# Staff Report

To: Salt Lake City Planning Commission  
From: Doug Dansie, Senior Planner, [doug.dansie@slcgov.com](mailto:doug.dansie@slcgov.com) or 801-535-6182  
Date: August 14, 2019  
Re: Central Station Apartments - Planned Development and Design Review (PLNSUB2019-00477 & PLNPCM2019-00399)

## Planned Development & Design Review

Sheet Number  
 A1.01

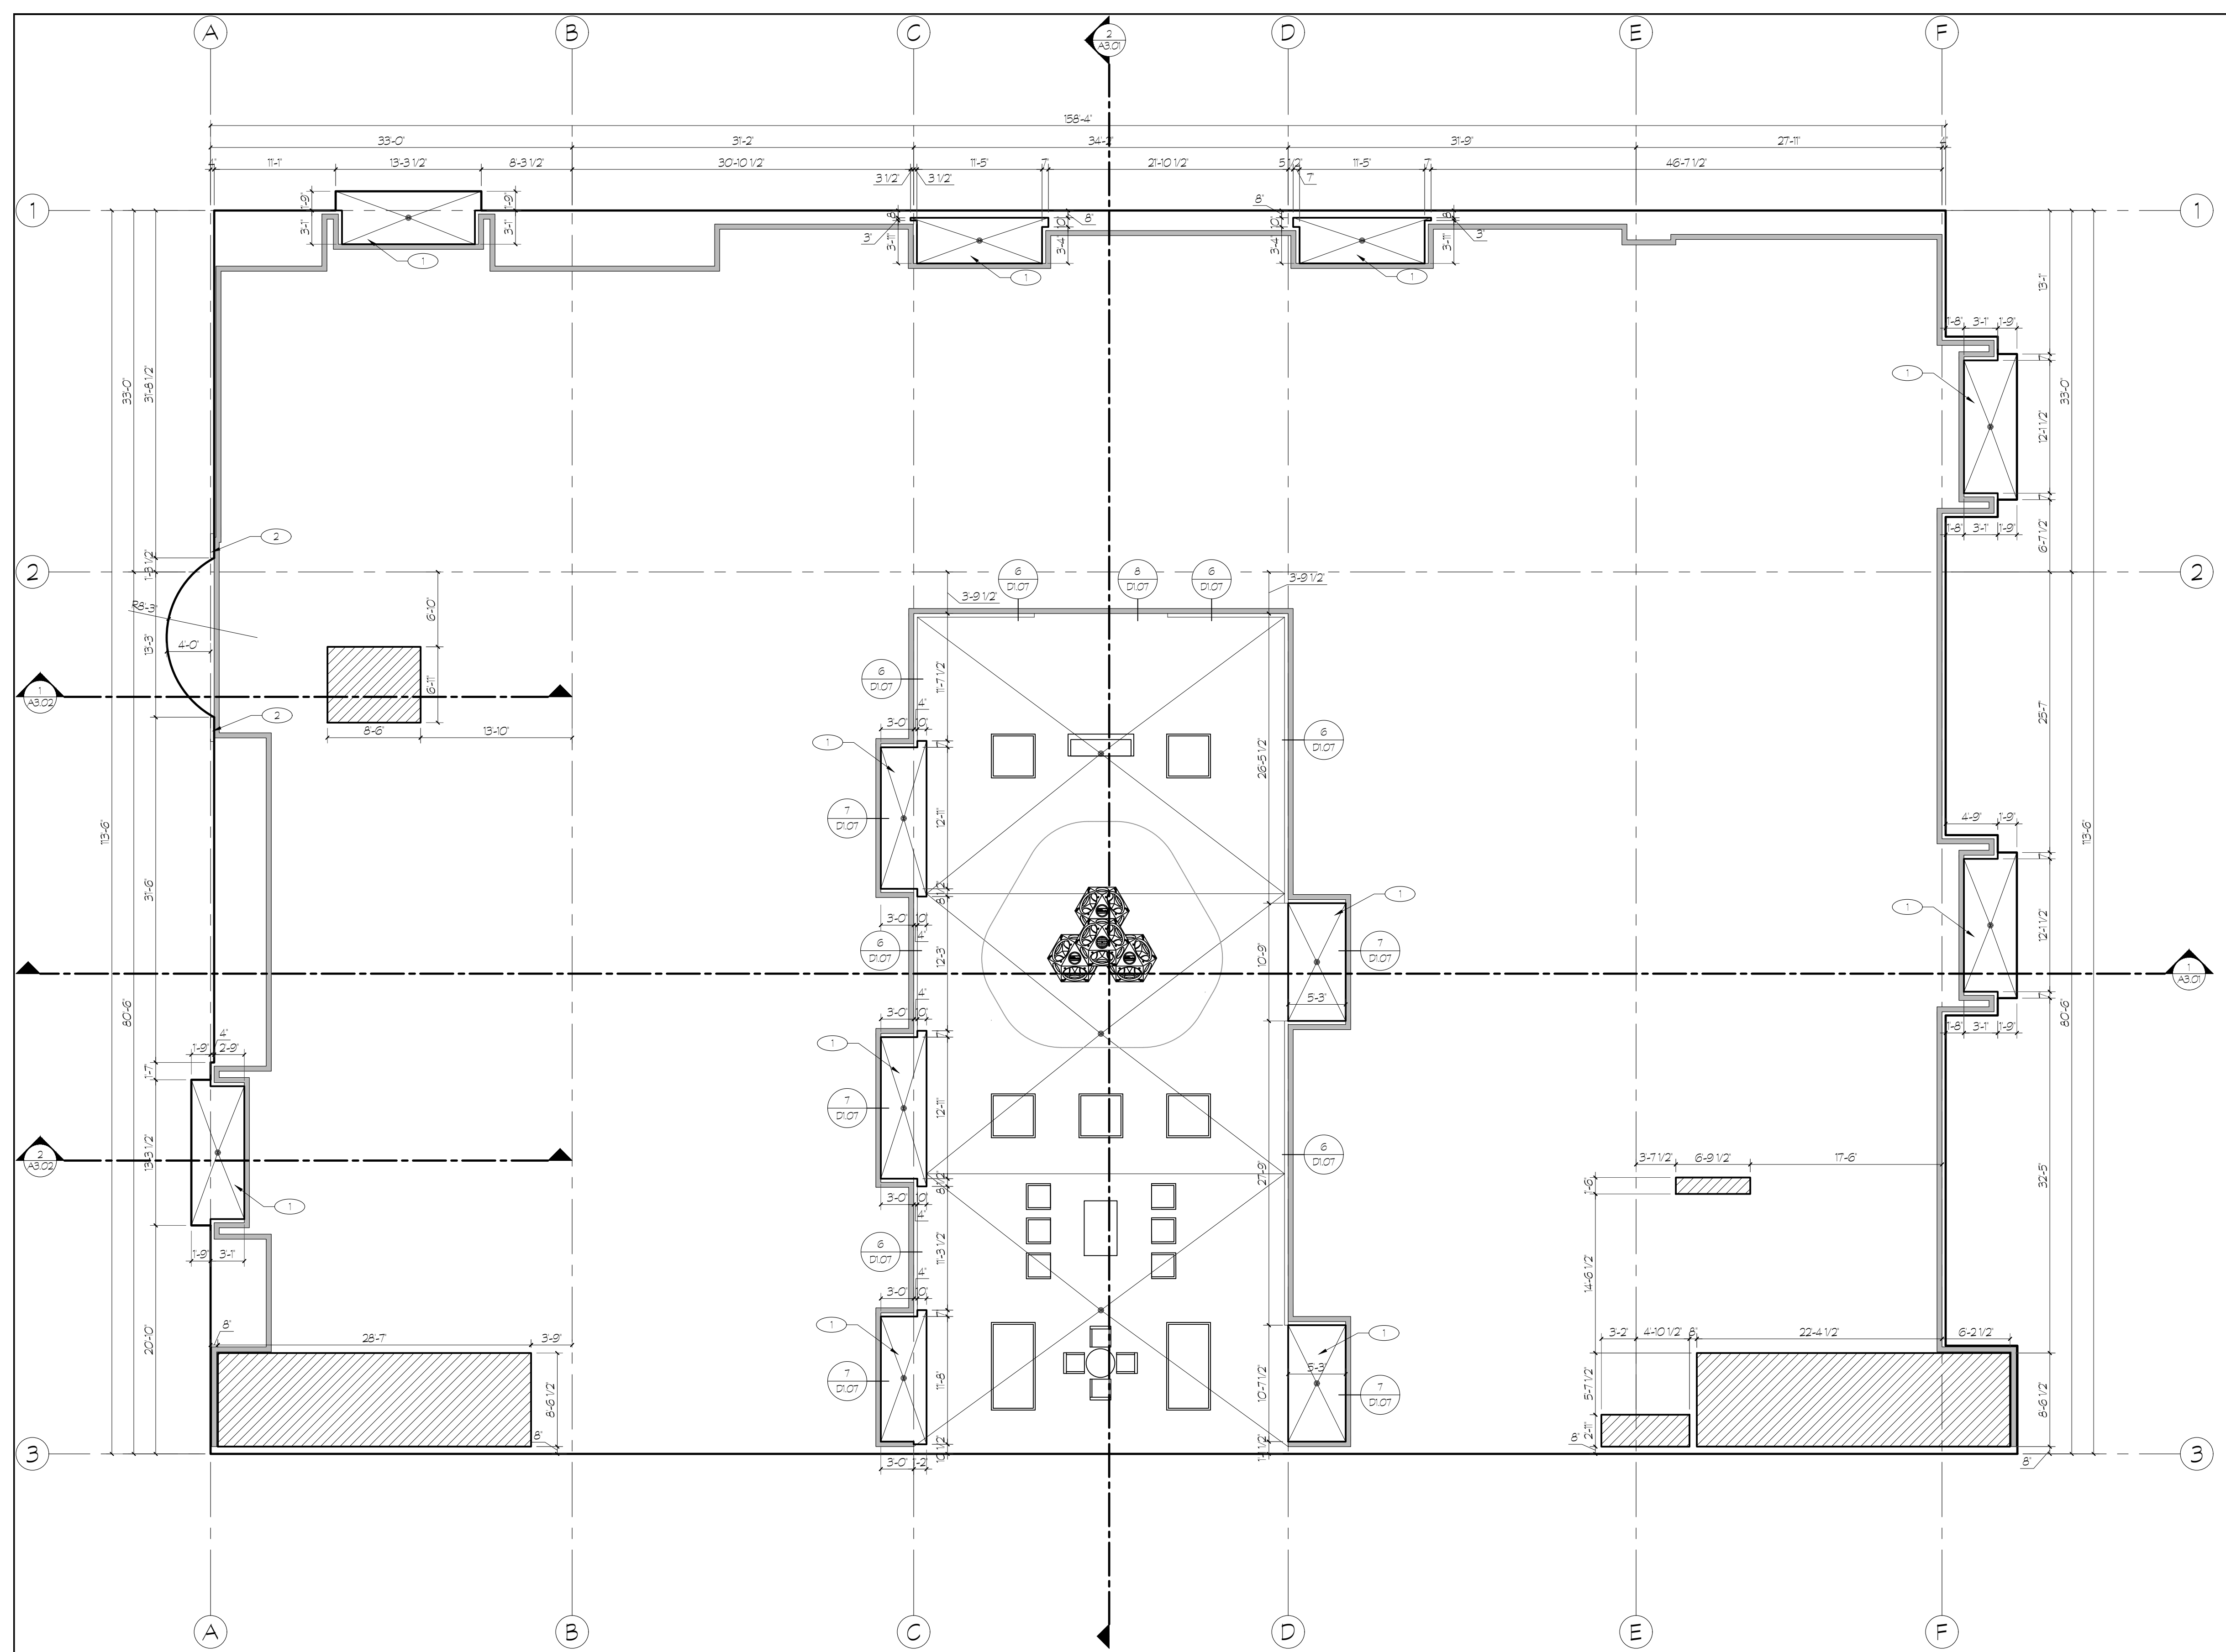
- A1.01 thru A1.07 show openings on the property line on the East. Openings are not allowed per IBC 705.8 less than 3 feet from property line. Note – Woodbine Street to the East is not a public way. This is a private street on an adjacent parcel.

**1 OVERALL PT DECK PLAN BETWEEN LEVELS 1 & 2**  
A1.02 SCALE: 1/8" = 1'-0"  
(24' x 36')

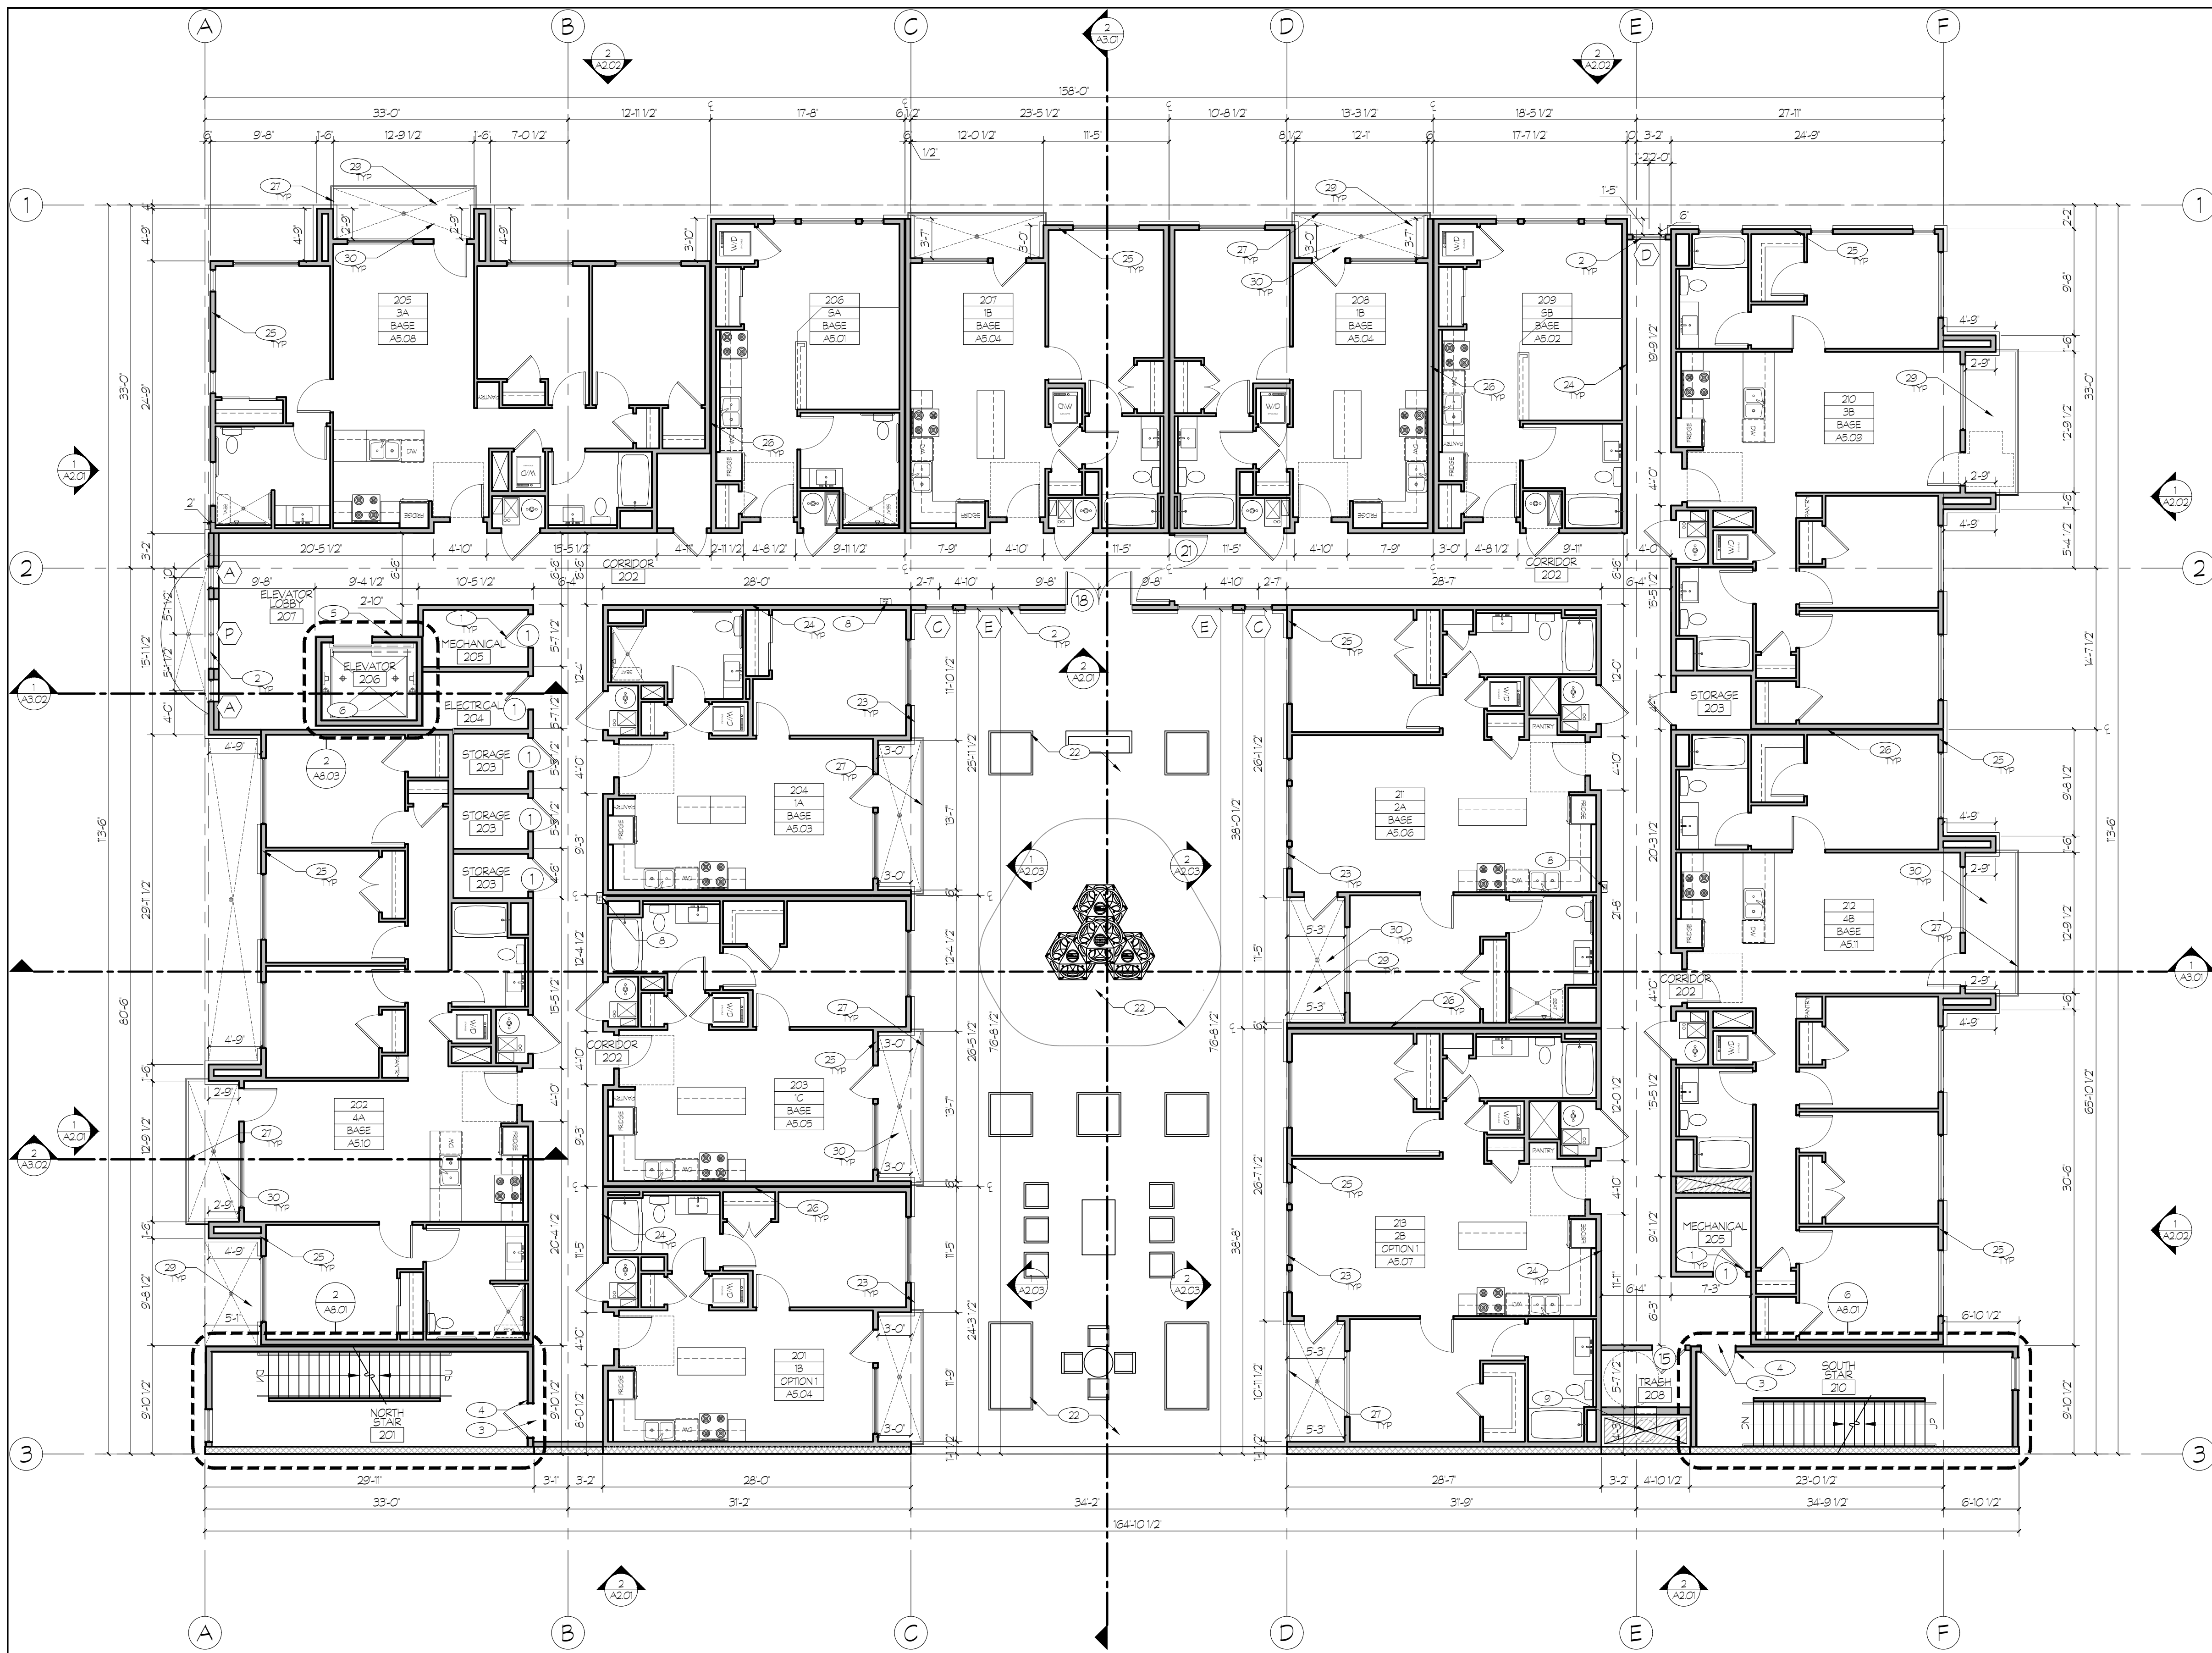
- A1.02 thru A1.08 show projections over, or right up to the property line on the North, South, and East. Projections are not allowed per IBC 705.2 less than 2 feet from property line. Note – Woodbine Street to the East is not a public way. This is a private street on an adjacent parcel.
